Technical Service Information

THM 4T80-E TURBINE SHAFT SPEED SENSOR CHANGES

CHANGE: Beginning in the 1996 model year, on Julian Date 113, all THM 4T80-E transaxles were produced with a new design case casting, manual shaft and turbine shaft speed sensor.

Figure 1

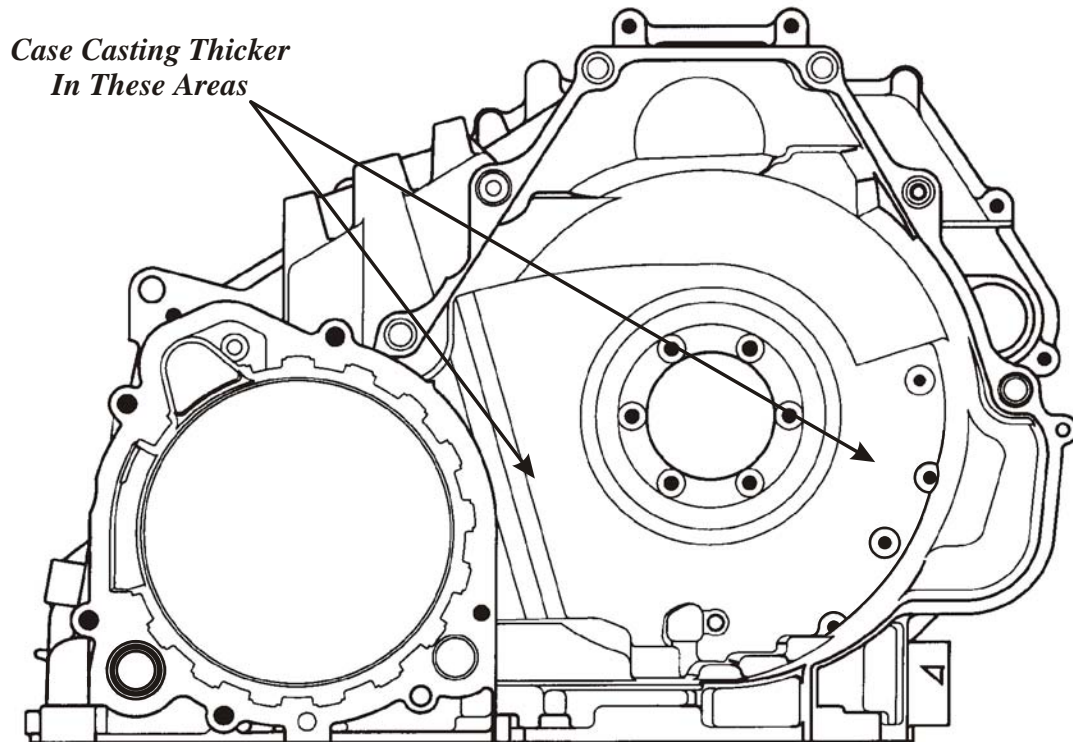
- (1) TRANSAXLE CASE - Thicker casting in the front seal area to help eliminate possible cracks and leakage and revised machining in the manual shaft seal bore area (See Figure 1).
- (2) MANUAL SHAFT - New design manual shaft has groove cut in shaft, to accept the bump on bottom of the turbine speed sensor wiring bracket, to locate and hold the manual shaft in the proper location in case (See Figure 1).
- (3) TURBINE SPEED SENSOR - Now manufactured with the bump on the bottom of turbine speed sensor wiring harness bracket, to position and retain manual shaft. The 1st design parts are shown in Figure 2 and the 2nd design parts are shown in Figure 3.

**1ST DESIGN MANUAL SHAFT
1993 TO 1996 (Julian Date 112)**

**2ND DESIGN MANUAL SHAFT
1996 (Julian Date 113) TO 2003**

Figure 2

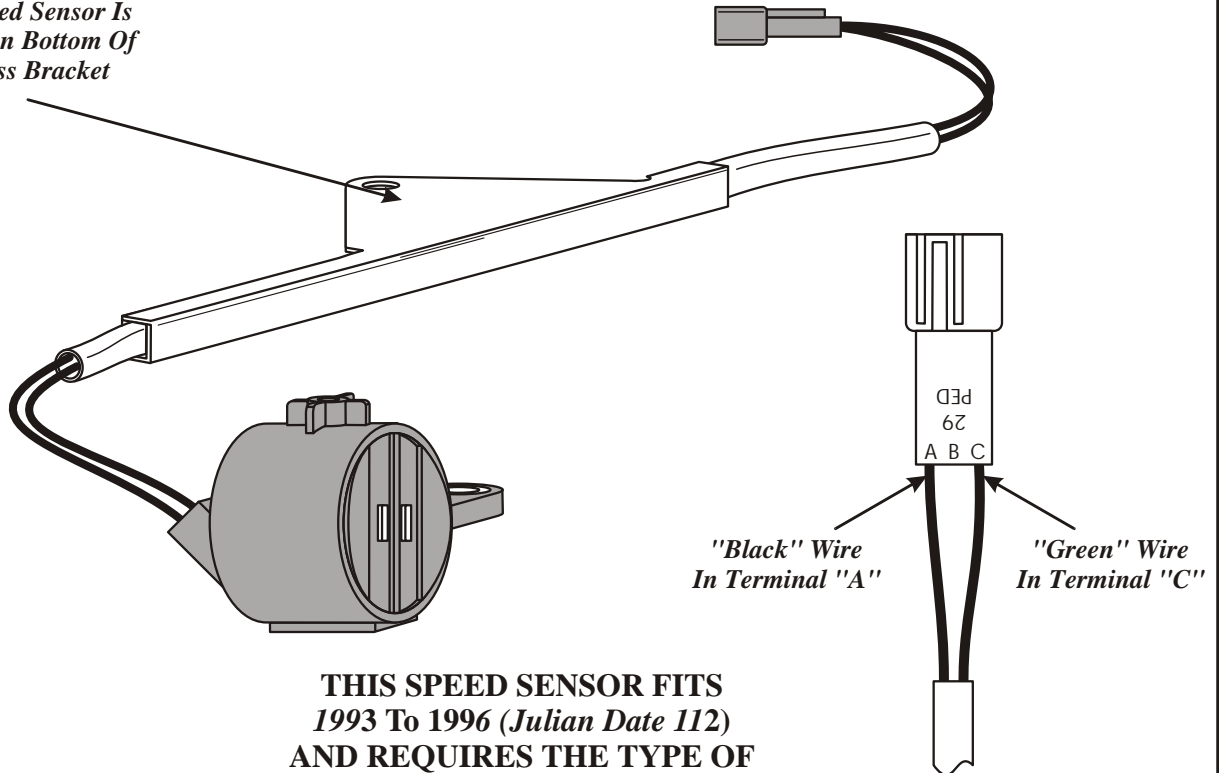
THM 4T80-E 1ST DESIGN TURBINE SHAFT SPEED SENSOR OEM PART NUMBER 24209654

*This Speed Sensor Is
"Flat" On Bottom Of
Harness Bracket*

**THIS SPEED SENSOR FITS
1993 To 1996 (Julian Date 112)
AND REQUIRES THE TYPE OF
MANUAL SHAFT SHOWN BELOW**

If it becomes necessary to replace the turbine speed sensor, ensure that your new sensor has the wires in terminals "A" and "C", as shown here. We have had some reports that the new sensor came with the green wire in terminal "B" and had to be moved to terminal "C". We have also had some reports of the black wire being in terminal "A" and the green wire being in terminal "B" on both sides of the connecting harness. Ensure that your wires match on both sides of connector, regardless of where they are located.

Figure 3

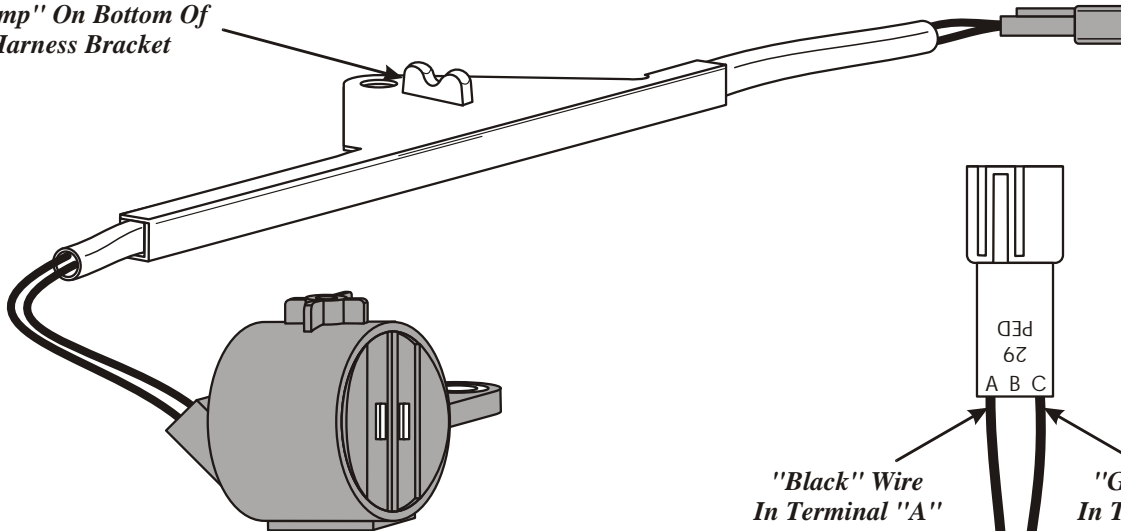
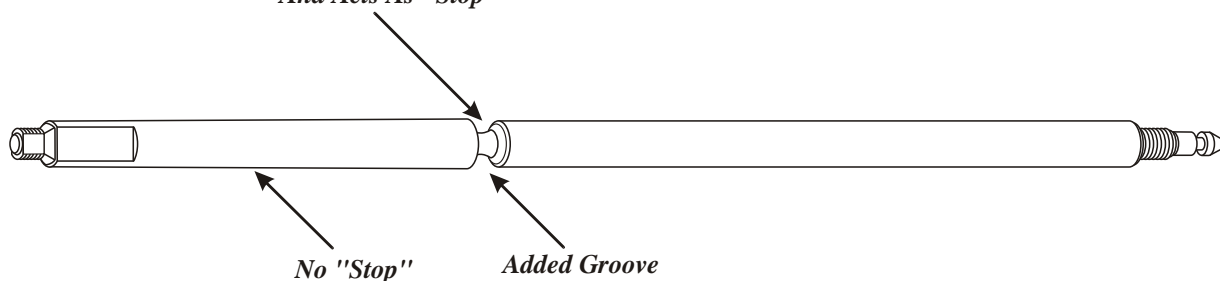
THM 4T80-E 2ND DESIGN TURBINE SHAFT SPEED SENSOR OEM PART NUMBER 24207491

*This Speed Sensor Has
"Bump" On Bottom Of
Harness Bracket*

**THIS SPEED SENSOR FITS
1996 (Julian Date 113) TO CURRENT
AND IS "MANDATORY" FOR
THESE MODELS AS TRANSAXLE
IS EQUIPPED WITH THE MANUAL
SHAFT SHOWN BELOW**

*"Bump" On Bottom Of Harness Bracket
Fits Into Groove In Manual Shaft And
Positions Manual Shaft In Case
And Acts As "Stop"*

If it becomes necessary to replace the turbine speed sensor, ensure that your new sensor has the wires in terminals "A" and "C", as shown here. We have had some reports that the new sensor came with the green wire in terminal "B" and had to be moved to terminal "C". We have also had some reports of the black wire being in terminal "A" and the green wire being in terminal "B" on both sides of the connecting harness. Ensure that your wires match on both sides of connector, regardless of where they are located.
